Re: Public Comment Concerning the Draft Groundwater Management Plan for the Cedar City Valley

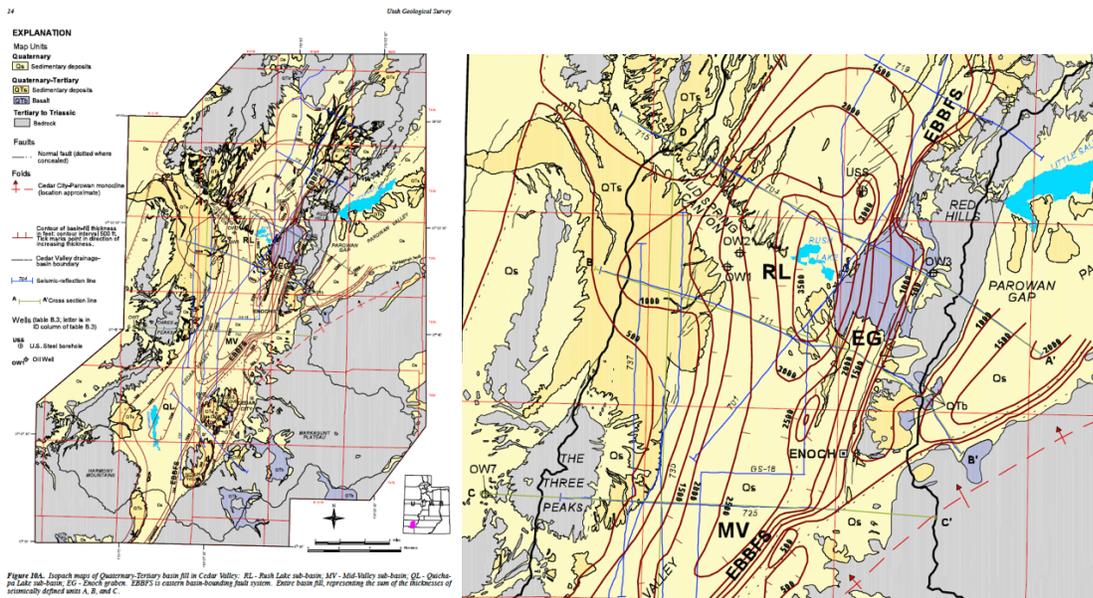
- ~8% are not directly in the unconsolidated basin fill (Three Peaks, Summit area – Unknown depletion, estimated to be light depletion)
- ~39% are in the Rush Lake sub-basin (light depletion)
- ~7% are in the Rush Lake sub-basin, but have been temporarily transferred to the Enoch Graben area each year (based in light but moved to heavy depletion)
- ~26% are in the Mid-Valley sub-basin (Moderate Depletion)
- ~8% are in the Enoch Graben area (Heavy Depletion)
- ~12% are in the Quichapa Lake sub-basin (Very Heavy Depletion)

This means that over 54% of the phase 1 cuts will be from areas of light depletion or unknown depletion (though 7% of the phase 1 cuts do have temporary change applications that move them to areas of Heavy Depletion each year). Approximately 20% of the phase 1 cuts will be in the Very Heavy or Heavy Depletion areas of the Enoch Graben and Quichapa Lake sub-basin. 26% will be in the Mid-Valley sub-basin with Moderate Depletion.

It is important to note that **46% of the rights slated to be cut are tied to the Rush Lake sub-basin where there is relative ground water equilibrium, and those rights account for 2083 af of depletion**

Figure 6. Areas of estimated subsurface inflow from adjacent consolidated rock to the unconsolidated basin fill, Cedar Valley, Iron County, Utah.

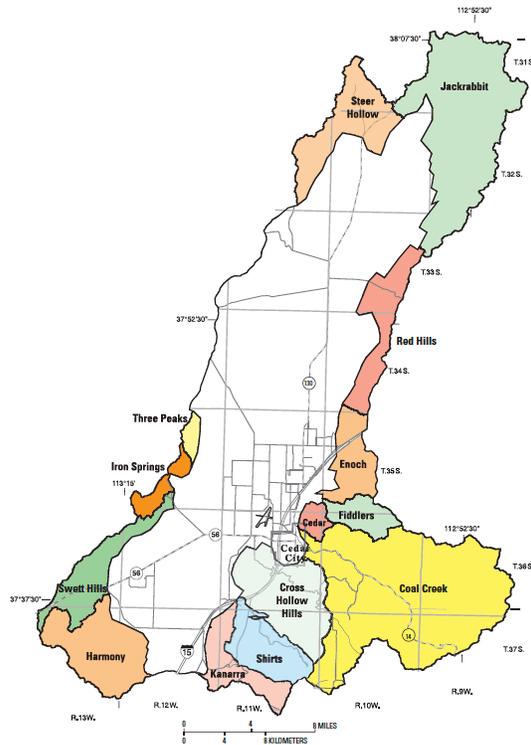
This balancing is important to consider in implanting a ground water management plan. While most of the valley recharges from the Coal Creek drainage, Rush Lake additionally recharges from the hills and mountains to the north and the east of Rush Lake, as well as from precipitation occurring on the unconsolidated fill to the north. The below charts, taken from the USGS 2005 study, shows that an estimated 5700 af of recharge to the basin aquifer comes from either north of Rush Lake or east of Rush Lake (2,200 af of recharge from precipitation on unconsolidated basin fill north of Rush Lake, 2,900 af of recharge from Jackrabbit and Steer Hollow north of Rush Lake, and 600 af of recharge from the Red Hills east of Rush Lake)

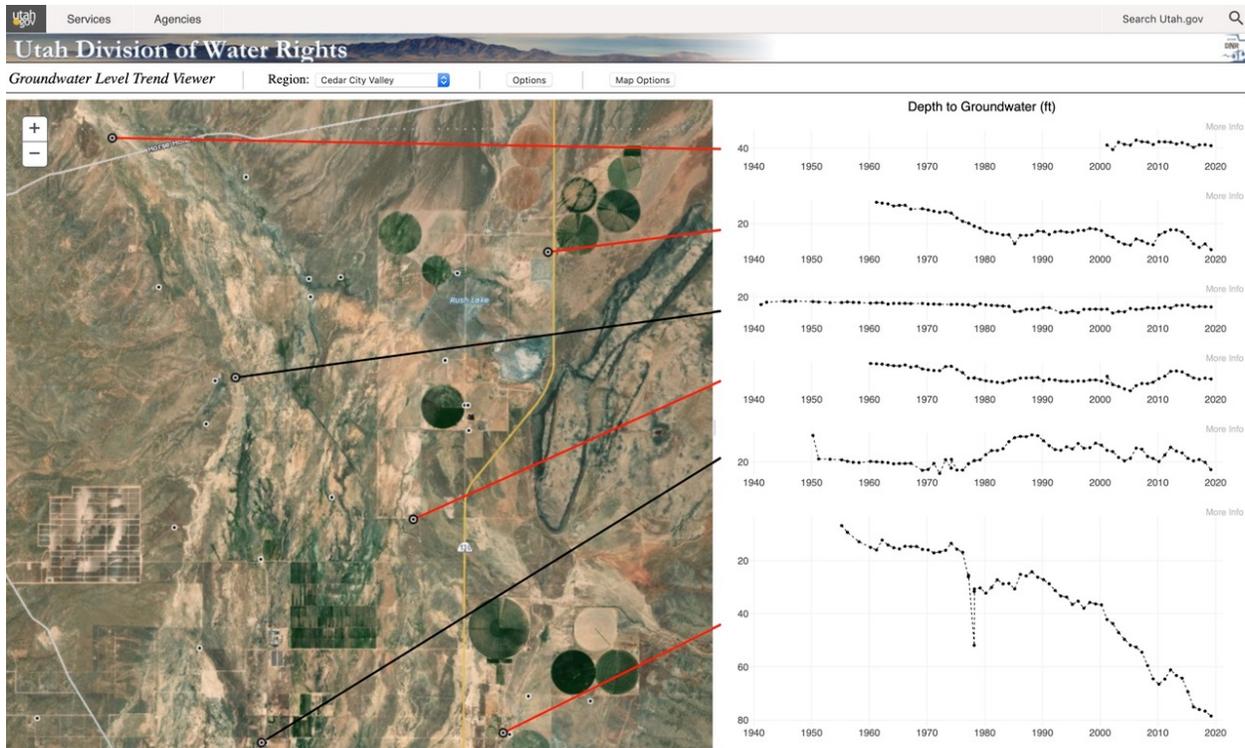
The USGS 2005 study suggested that the withdrawal's occurring south of the Rush Lake sub-basin are "possibly captur(ing) water that previously flowed north to this area" pg 26. This assumption could further be supported by the well logs shown on the Division of Water's website. The well logs around Rush Lake are relatively stable, while the well logs directly south of Rush Lake are showing ground water level declines (this particular well might be located in the Enoch Graben, an area with a geologic barrier preventing ground water from flowing E-W). Well logs to the southwest are steady, however, possibly experiencing recharge from the Cedar City Water Treatment facility.
